PH MARCH 2016
REV 2

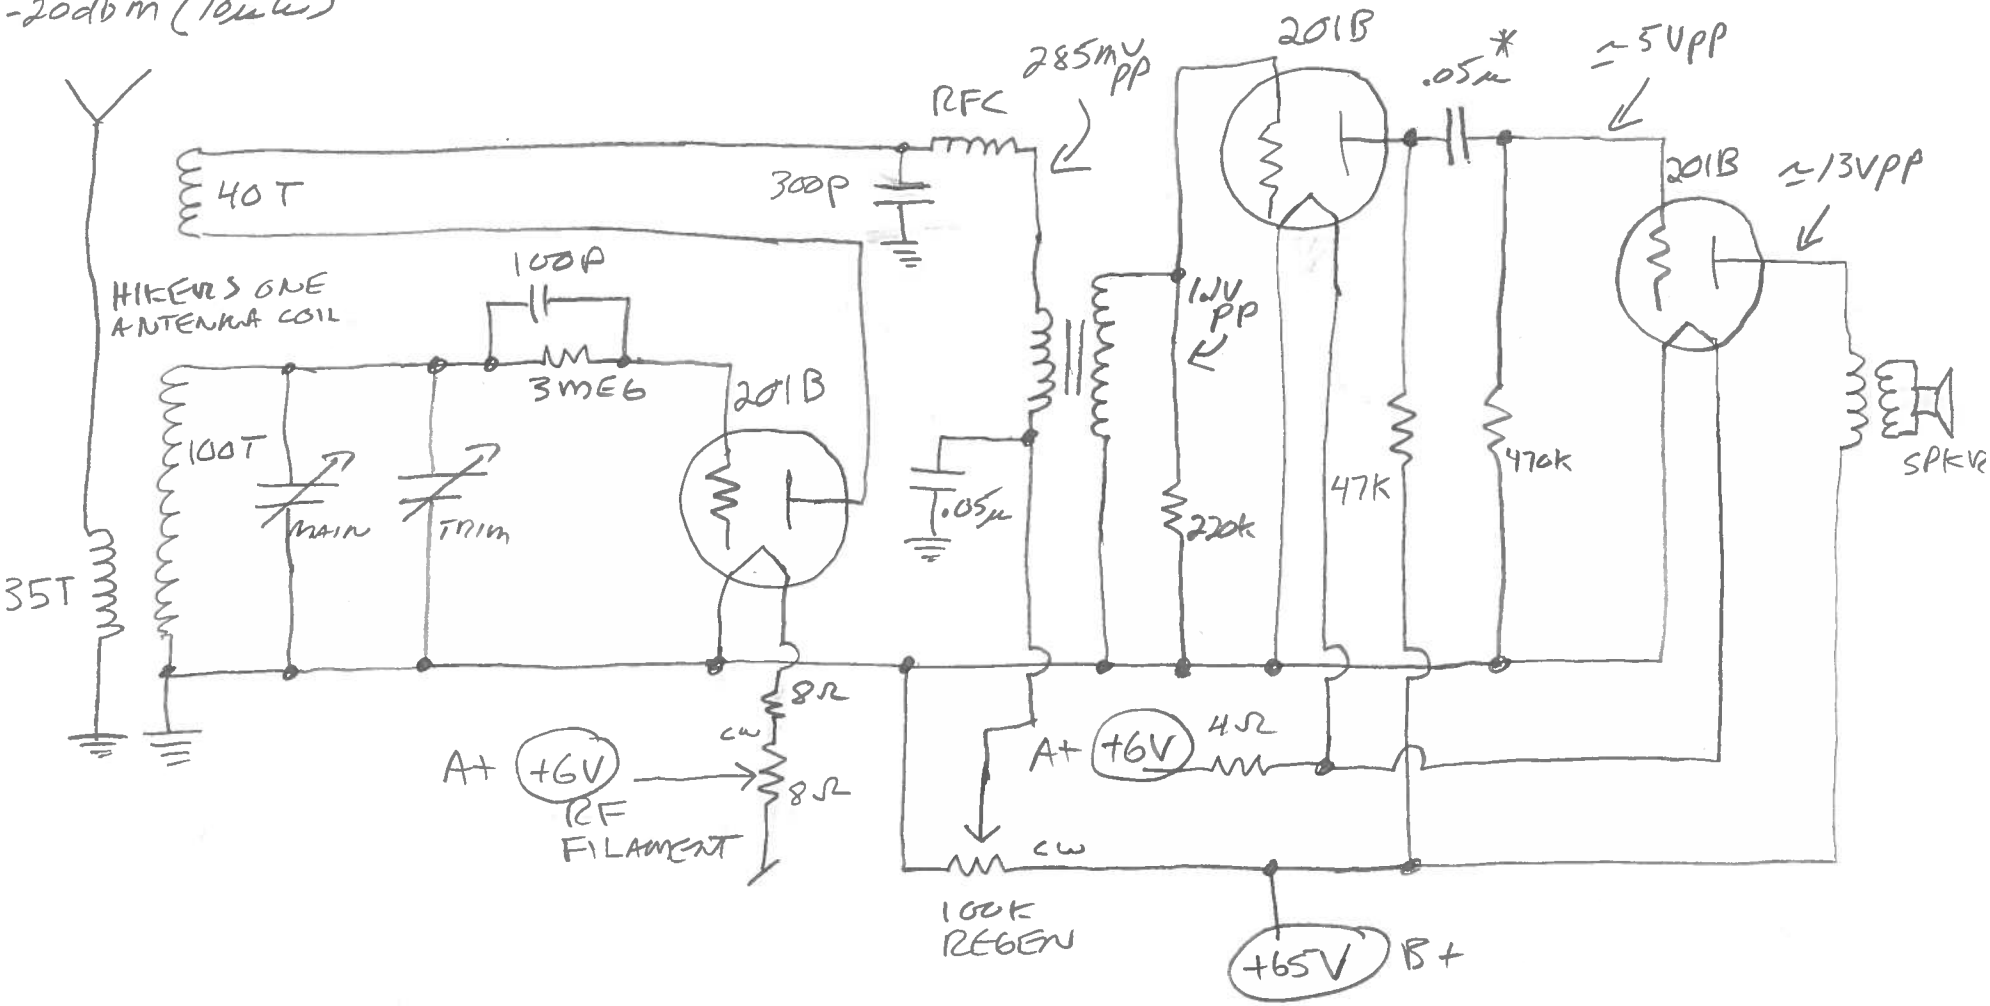
* .05μ TO BE REPLACED BY 500 SET TRANSFORMER FOR APPROX 6 TO 8 db MORE GAIN... (TBD.)
